JL Fashions Limited (relocated)

Baniarchala, Mahna, Vhabanipur, Gazipur Sadar

12th & 18th August 2021

1. Main Building (G+5)
2. Facility Building (G+5)
3. Utility Building (B+G+1)
4. Boiler Shed (Single Storied)
5. Security Building (Single Storied)

Column Layout Plan- marked portion toilet block

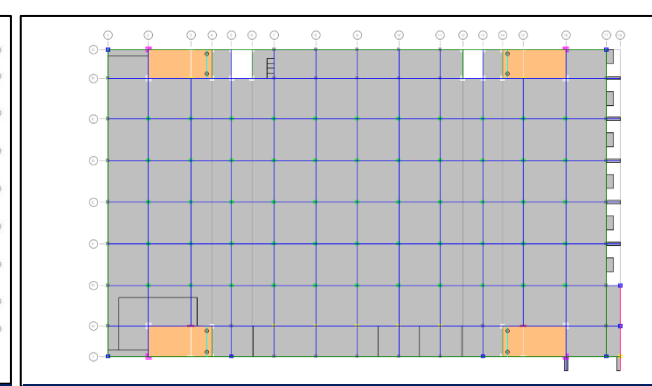
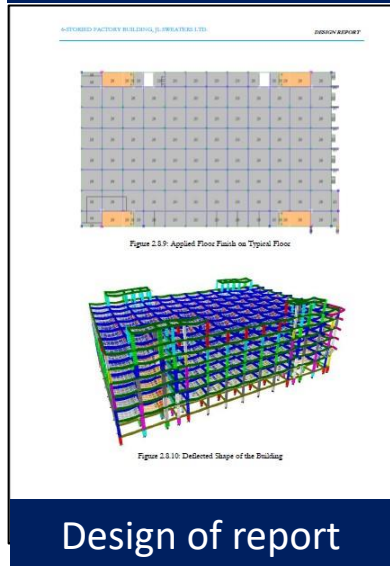
Toilet block has not been assigned in FEA model

The toilet block is connected at foundation with the Main Building. And there is an expansion gap between the structures. The assessment of the toilet block has not been included in design report. Factory engineer is required to assess the toilet block including the foundation adequacy.

As per BNBC, every building or structure designed shall have its design documents prepared in accordance with the provision of Section 1.9.1. The design document shall include a design report, and a set of structural drawings, which shall be prepared in compliance with section 1.9.1.1 and section 1.9.1.2 as per BNBC. Revise the software-based analysis model, design report & documents following BNBC requirements.

Foundation adequacy check table in report

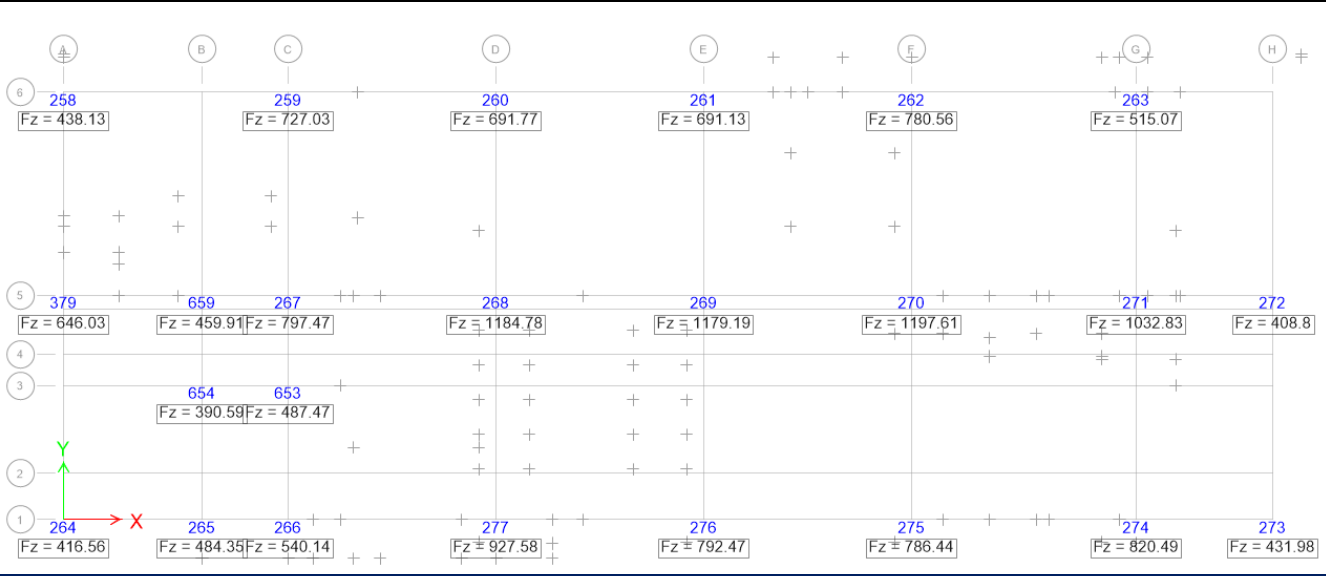
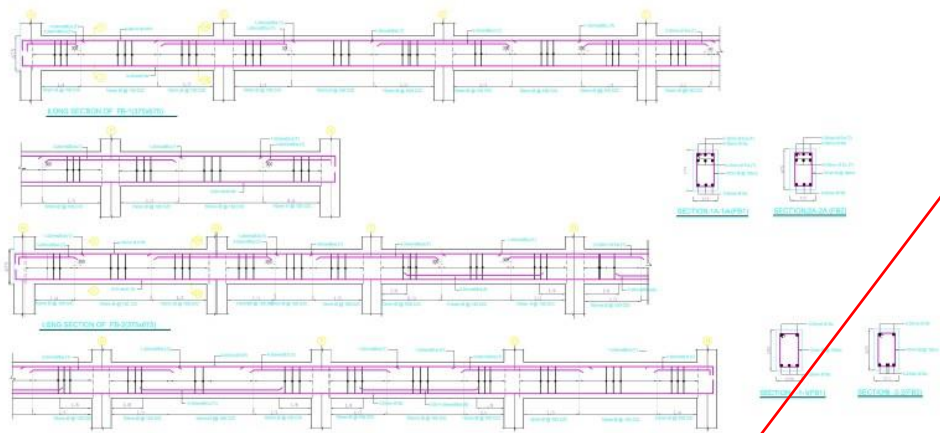
In foundation adequacy table the size of the footing has been considered larger size than the size provided in footing schedule of the as built drawing. Also, the base reaction from FEA model does not match with the load in foundation adequacy table.

As per BNBC, every building or structure designed shall have its design documents prepared in accordance with the provision of Section 1.9.1. The design document shall include a design report, and a set of structural drawings, which shall be prepared in compliance with section 1.9.1.1 and section 1.9.1.2 as per BNBC. Revise the software-based analysis model, design document following BNBC requirements.

$f'_c = 4000$ psi has been assigned in FEA model for beam

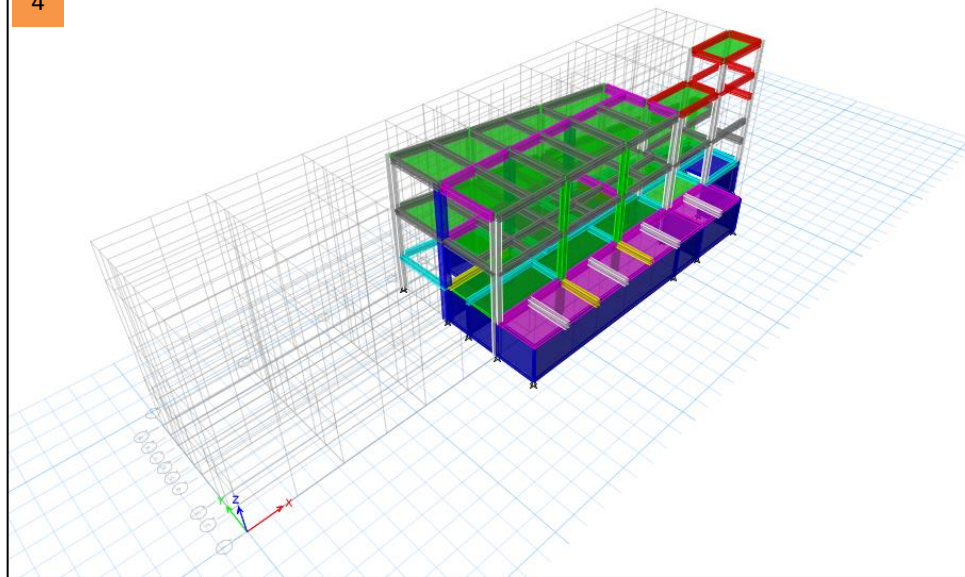
In drawing the concrete design strength for beam has been shown 3500 psi but in the FEA model, 4000 psi has been assigned.

1. Footing layout, 2. Column Layout, 3. Beam Layout

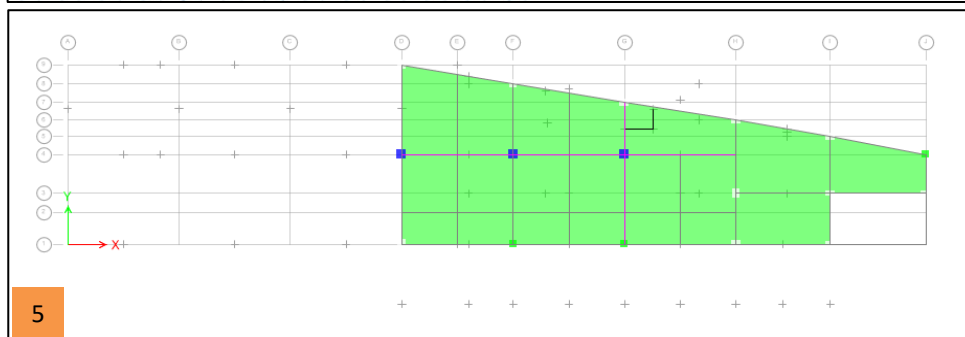
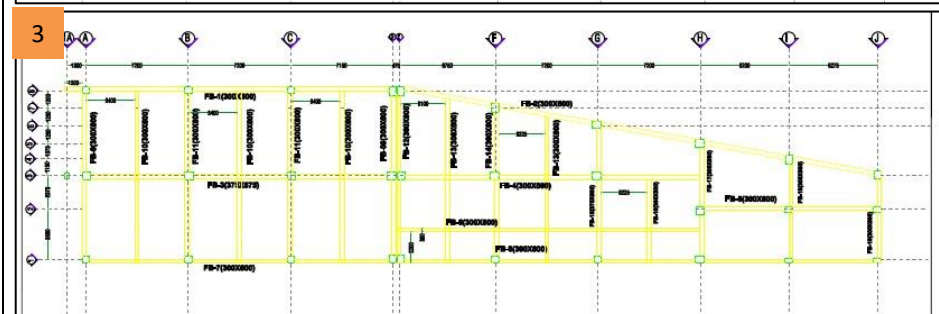
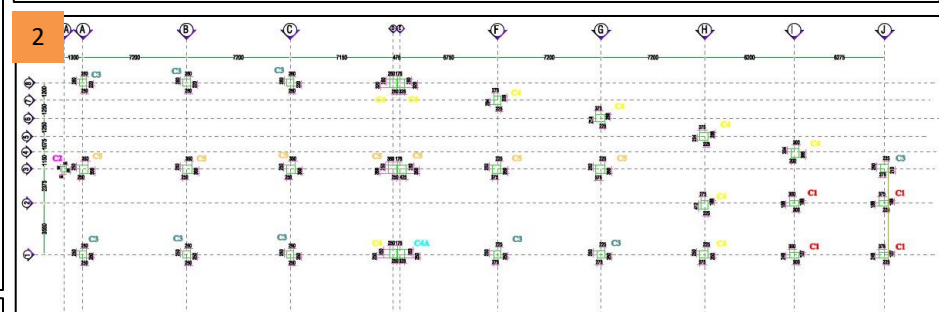
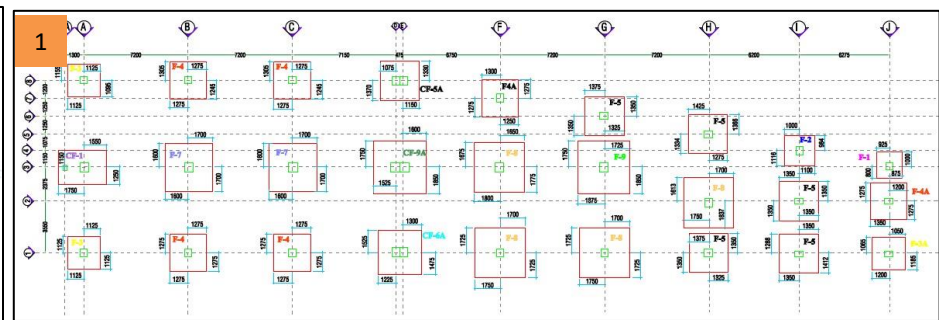
4. 3D view, 5. Plan view of the structure in FEA model. In FEA model whole structure has not been assigned as per drawing & site condition.

As per BNBC, every building or structure designed shall have its design documents prepared in accordance with the provision of Section 1.9.1. The design document shall include a design report, and a set of structural drawings, which shall be prepared in compliance with section 1.9.1.1 and section 1.9.1.2 as per BNBC. Revise the software-based analysis model & design document following BNBC requirements.

2 nos. Plastic Water Tank on roof top slab
(Capacity- 2000 & 1000 Liter)

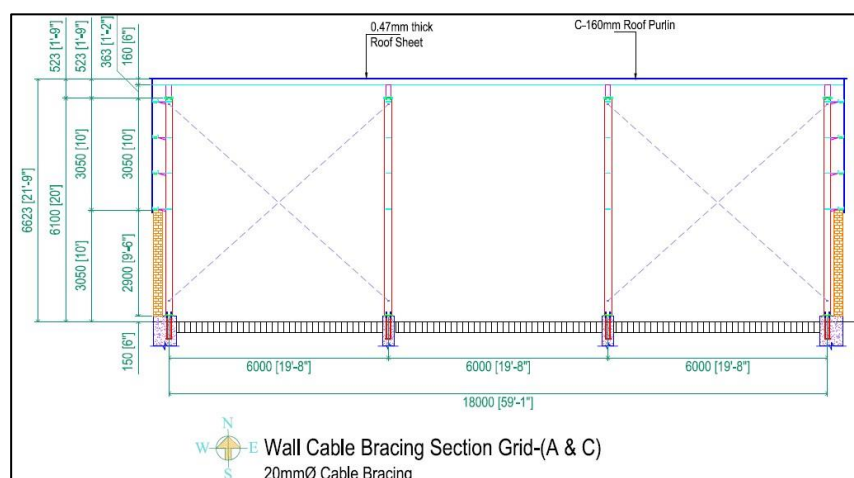
3 nos. undocumented plastic water tank found on roof top where 1 nos. 2000 liters plastic water tank rest on 57 inch build up. The factory engineer is required to check the adequacy of slab considering these undocumented water tanks whether it is satisfactory or not. Also, update the as-built drawing and load plan.

Wall Bracing Layout plan

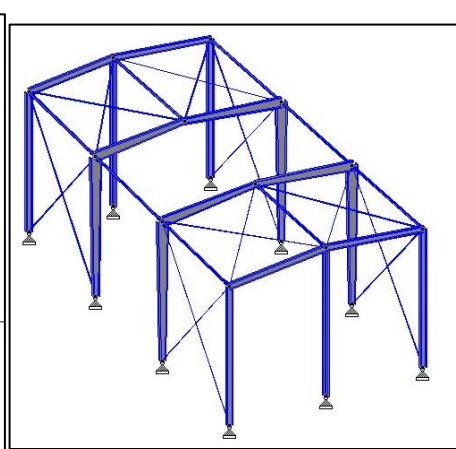
The assessment of the structure has been conducted considering wall bracing, but during inspection wall bracing was not found at factory site. Factory engineer is required to revise the design documents as per actual site condition

As per BNBC, every building or structure designed shall have its design documents prepared in accordance with the provision of Section 1.9.1. The design document shall include a design report, and a set of structural drawings, which shall be prepared in compliance with section 1.9.1.1 and section 1.9.1.2 as per BNBC. Prepare the software-based analysis model based on actual site condition and revise design documents following BNBC requirements.
